Project	IEEE 802.16 Broadband Wireless Access Working Group < http://ieee802.org/16 >	
Title	Normal MAP Extension for H-ARQ	
Date Submitted	2005-01-25	
Source(s)	Yigal Eliaspur, Yuval Lomnitz, Zivan Ori Intel Corp.	yigal.eliapsur@intel.com , yuval.lomnitz@intel.com , zivan.ori@intel.com
	Geunhwi Lim, Jiho Jang, Wonil Roh, Yong Chang, Seungju Maeng Samsung Electronics Co. Ltd.	geunhwi.lim@samsung.com , yongchang@samsung.com
	Ran Yaniv Alvarion Ltd.	ran.yaniv@alvarion.com
	Mo-Han Fong, Wen Tong Nortel Networks	mhfong@nortelnetworks.com
	Bin-Chul Ihm LG Electronics, Inc.	bcihm@lge.com
	Mary Chion, Irving Wang ZTE San Diego Inc.	mchion@ztesandiego.com
	Sungcheol Chang, Chulsik Yoon	scchang@etri.re.kr
	ETRI	
	Kamran Etemad Greg Schumaker Nextel Communications	kamran.etemad@nextel.com
	John J. Humbert IV Sprint	jhumbe01@sprintspectrum.com
	Radu Selea, Bogdan Franovici Redline Communications	radu@redlinecommunications.com

Kamlesh Rath, Trevor Pearman, Brett Schein, Erik Lindskog Beceem Communications, Ltd	
Re:	IEEE P802.16e/D5a

Abstract	The document contains suggestions for extending the Normal MAP for H-ARQ support. Additionally, certain MAC fixes are described for H-ARQ support.
Purpo

Figure XX – H-ARQ downlink allocation

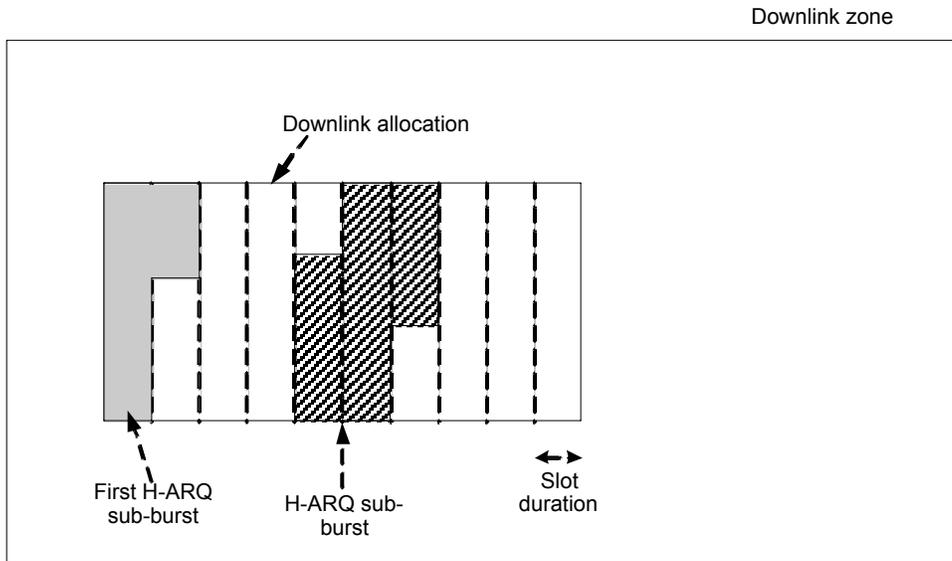
The H-ARQ DL MAP IE defines one or more two dimensional data regions (a number of symbols by a number of subchannels). These allocations are further partitioned into bursts, termed sub-bursts, by allocating a specified number of slots to each burst. . All sub-bursts of a data region shall only support one of the H-ARQ modes. The number of slots is indicated by duration or N_{sch} fields. The slots are allocated in a frequency-first order, starting from the slot with the smallest symbol number and smallest subchannel, and continuing to slots with increasing subchannel number. When the edge of the allocation is reached, the symbol number is increased by a slot duration, as depicted in the following diagram. Each sub-burst is separately encoded.

Figure 23a Sub-MAP Burst

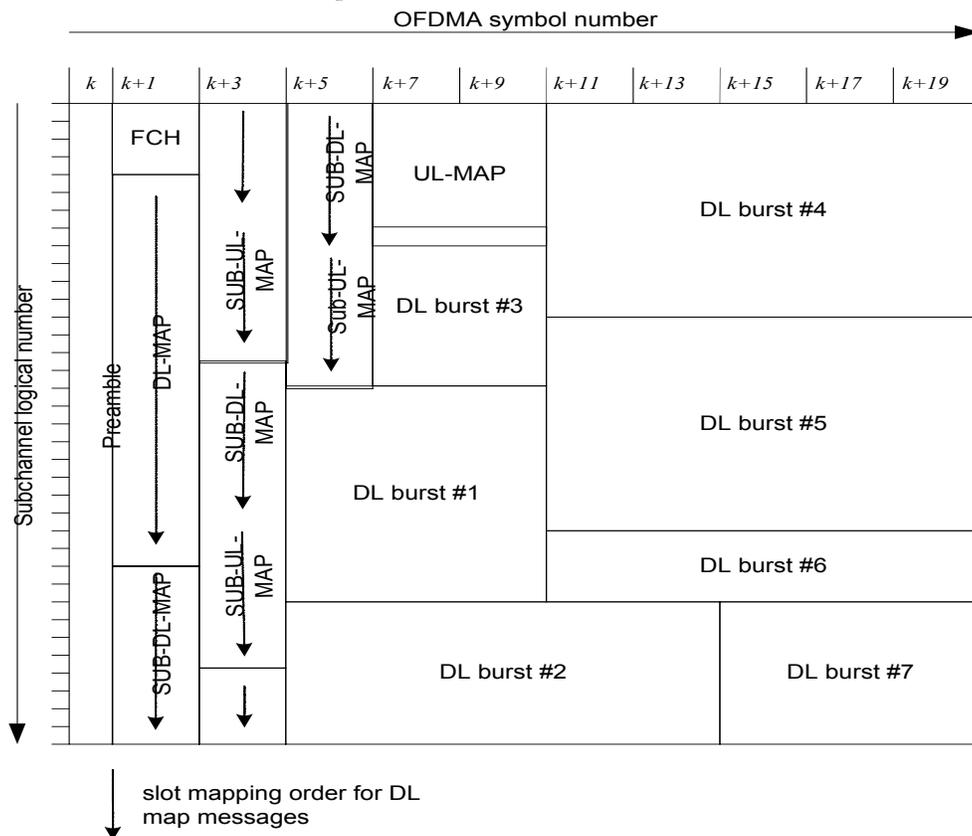
6.3.2.3.59 Sub downlink/uplink map (SUB-DL-UL-MAP) message

The SUB-DL-UL-MAP message shall appear in a compressed form, in which the generic MAC header is

omitted. This is indicated by setting the two most significant bits of the first data byte in the message's PHY burst to 1 (an invalid combination for a generic MAC header).
